UNITED STATES  
DEPARTMENT OF THE INTERIOR  
BUREAU OF LAND MANAGEMENTHobbs Field Office  
OCD HobbsFORM APPROVED  
OMB NO. 1004-0137  
Expires: January 31, 2018**SUNDRY NOTICES AND REPORTS ON WELLS**  
*Do not use this form for proposals to drill or to re-enter an abandoned well. Use form 3160-3 (APD) for such proposals.*5. Lease Serial No.  
NMLC032096B

7. If Unit or CA/Agreement, Name and/or No.  
NMNM112723X8. Well Name and No.  
EAST BLINEBRY DRINKARD UNIT 209. API Well No.  
30-025-0648110. Field and Pool or Exploratory Area  
EUNICE; B-T-D, NORTH11. County or Parish, State  
LEA COUNTY COUNTY, NM

Apache proposes the attached conformance procedure and WBD's to workover this injection well. (EBDU Waterflood Project Case 13503 R-12394)

**Apache Corporation  
East Blinebry Drinkard Unit 20  
API 3002506481  
May 24, 2018**

## Proposed

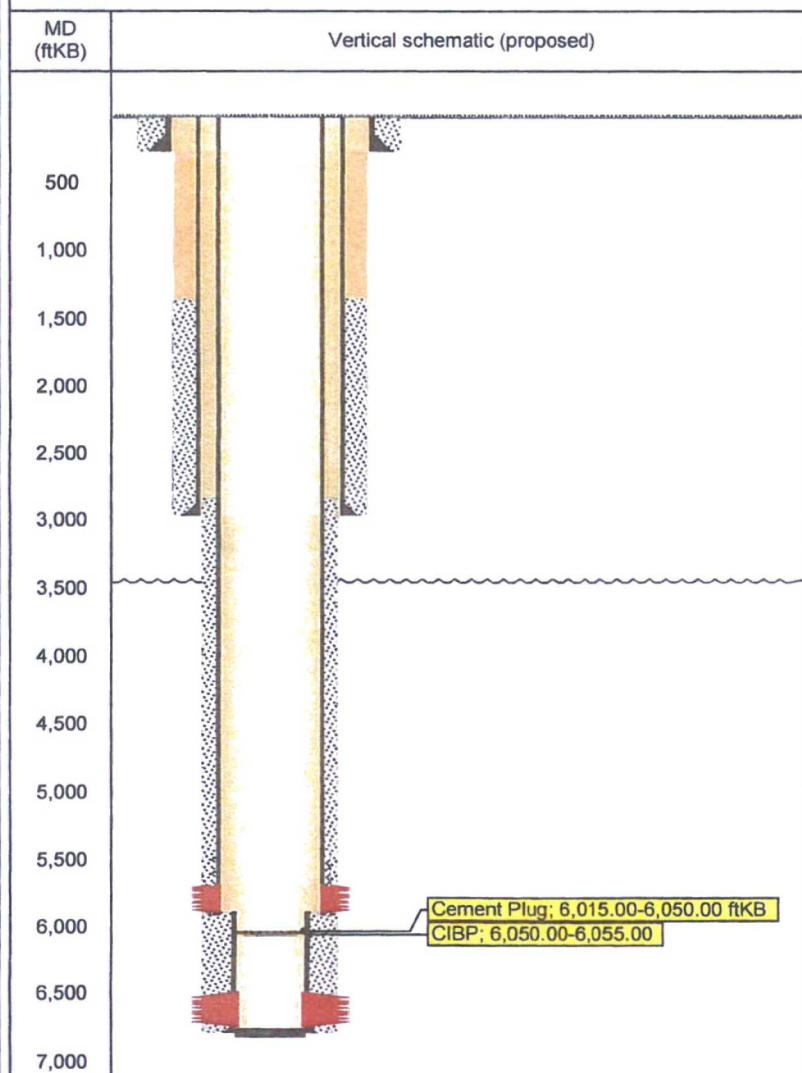
3. TIH with CIBP and work string. Set CIBP at ~6,050' and cap with <sup>35' of</sup> ~~2 sacks~~ of Class "C" cement. *on 25 sacks*.
4. TOH with work string.
